Road Safety Improvements on Cummer Avenue

Public Consultation Report

January 2021

Map of proposed protected bike lanes and shared cycling markings in the Bayview Woods neighbourhood.

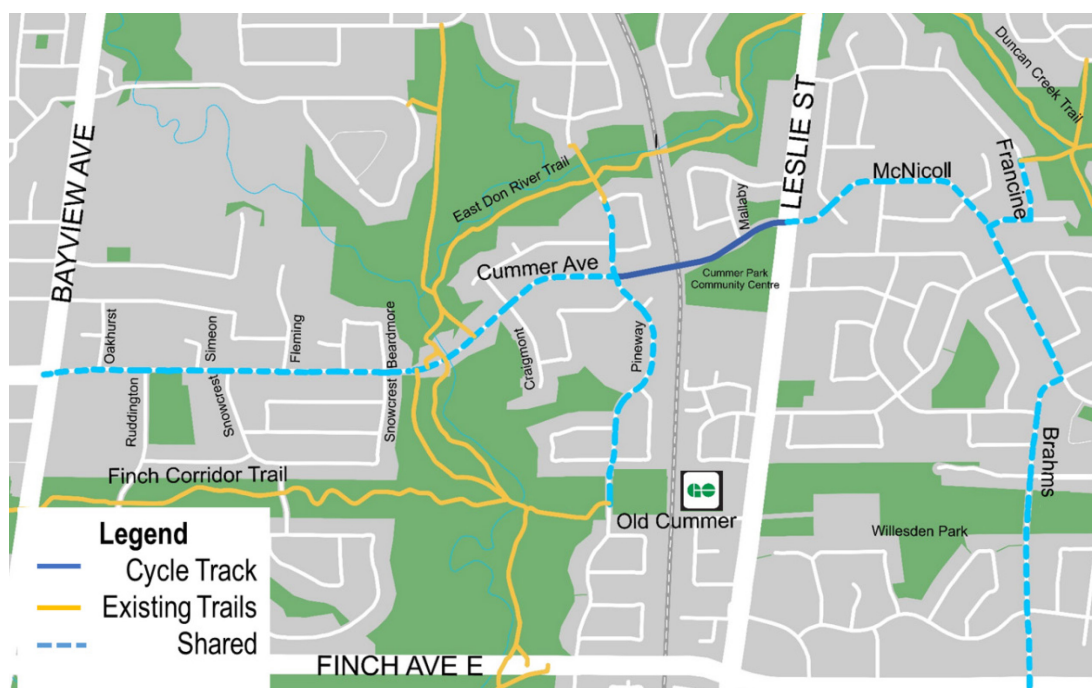
Generally, the majority of participants were supportive of protected bike lanes in this section (Pineway Avenue to Leslie Street), but expressed interest in seeing them extended to the whole corridor (Bayview Avenue to Leslie Street), to other major corridors (i.e. Yonge St) as well as to other cycling routes (i.e. the McNicoll Avenue bike path, the Finch Hydro Corridor).

Feedback was very supportive of the safety measures, including raised crosswalks, wider sidewalks, curb extensions and speed humps. In fact, they suggested the City implement those safety measures as well as new stop signs along the entire stretch of Cummer Avenue, from Bayview Avenue to Leslie Street).

Separated bike lanes are preferred along the entire corridor (Bayview Avenue to Leslie Street).
